RIVER DISTRICT SPECIFIC PLAN

Final Environmental Impact Report (SCH 2009062023)
December 2010

**River District Specific Plan
Final EIR**

Figure 5.10 Bicycle Circulation Map

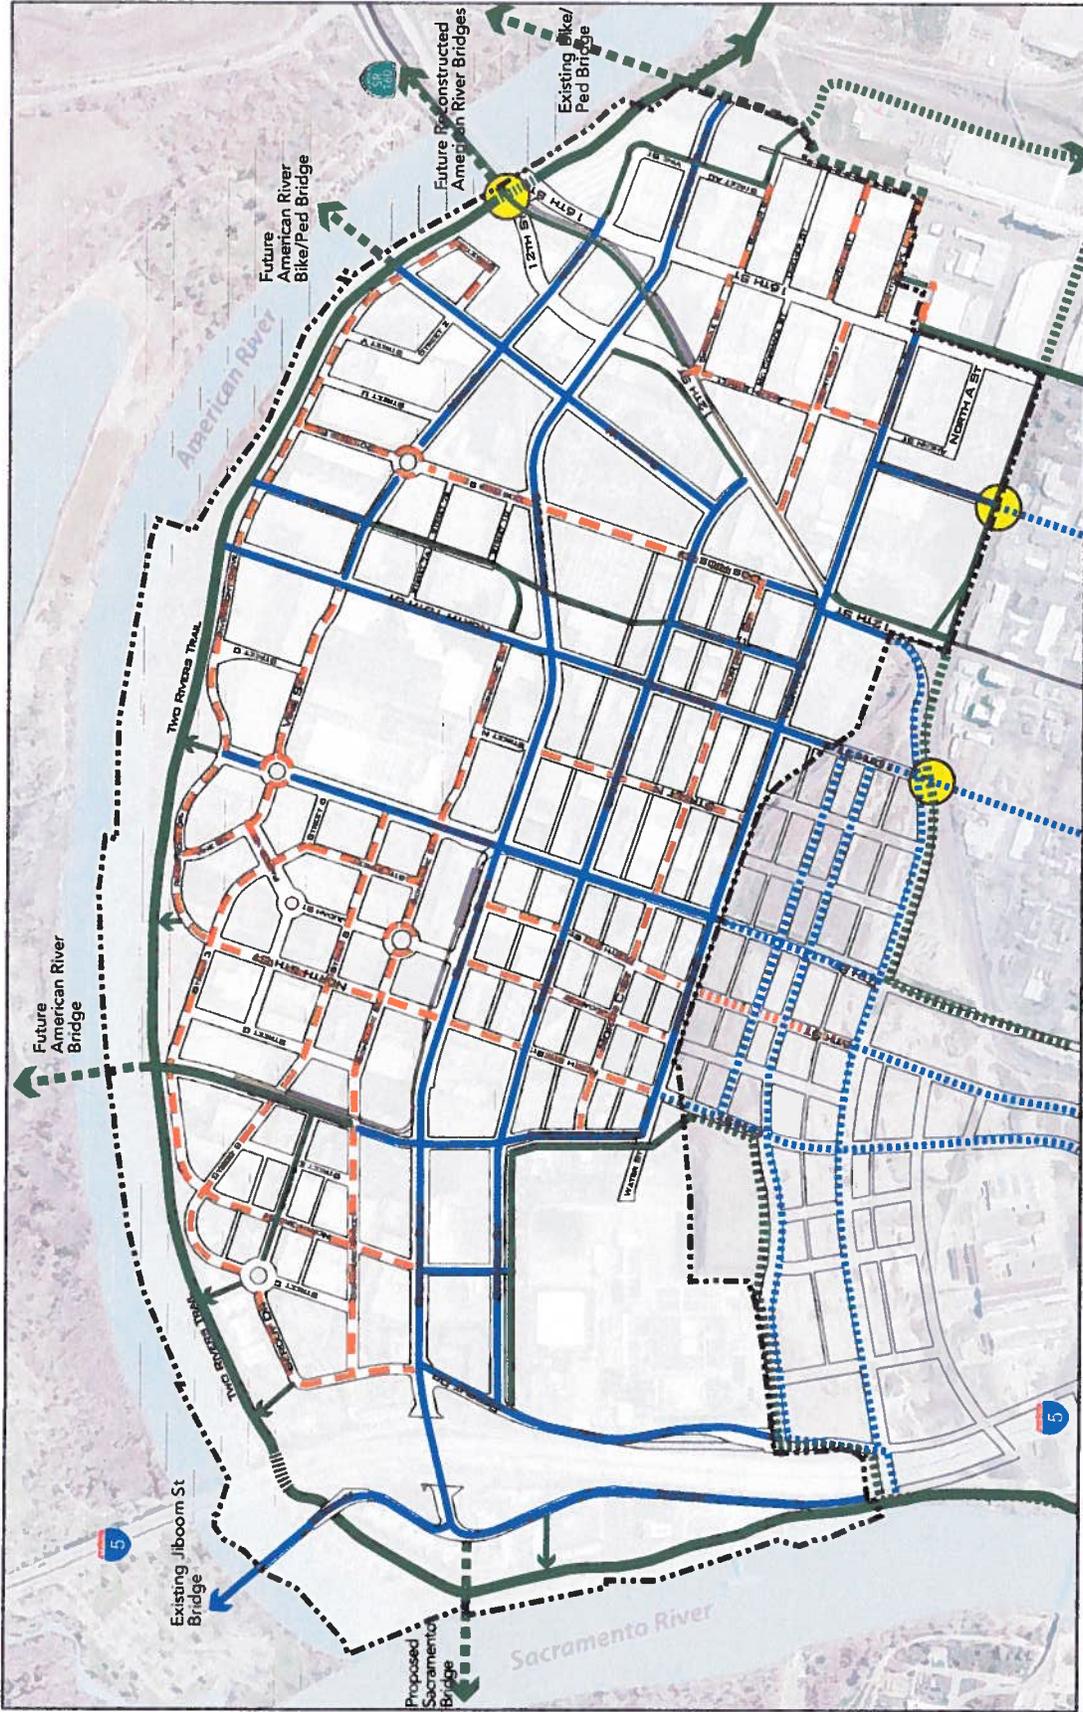
We are unclear about some differences between Figure 3-6, the proposed project “circulation map,” and Figure 5.10-2: Existing and Proposed Bikeways in the 2010 Bikeway Master Plan. Figure 3-6 shows proposed vehicular circulation with bike lanes shown for certain street segments. We request that a separate bicycle circulation map be prepared that shows the proposed key bicycle routes within the project that will connect key destinations and key external access points. The two light rail stations and high concentrations of employment and shopping are key destinations. Key access points for bicyclists would be the Sacramento Northern Bridge, 16th Street (or vicinity), 7th Street, Jibboom Street to Discovery Park, and the future Sequoia Pacific Blvd. bridge to South Natomas.

⁵ / It should be noted that Figure 3-6 of the DEIR suggests that North 10th Street will have “no bike lanes.” This Figure must be reconciled with the page 5.10-3 of the DEIR, which provides that North 10th Street will include “on-street bikeways.”

J-3 As shown on Figure 5.10 (see attachment after Letter F), there will be Class I through III bicycle facilities on all existing and proposed streets within the RDSP area, with the exception of 12th and 16th Streets. As requested in the comment, the bicycle routes connect key destinations within, and outside of, the RDSP project area.

As noted on Figure 5.10, Bicycle Circulation Map, a grade-separated bicycle/ pedestrian throughway is proposed to allow access east of the Highway 160 bridge. Construction of this throughway is not part of the proposed project and is a part of the master planning of the Two Rivers Trail.

Figure 5.10 also shows bike trails on the future bridges across the Sacramento River and the American River. Because the design and construction of those bridges is not currently known, and will be done by others, more specific information is not currently known.

Figure 3-6, the River District Specific Plan Circulation Map, is incorrect in that it shows that North 10th Street will not have bikeways. As shown on the attached Figure 5-10, Bicycle Circulation Map, there will be Class II bike lanes on North 10th Street.
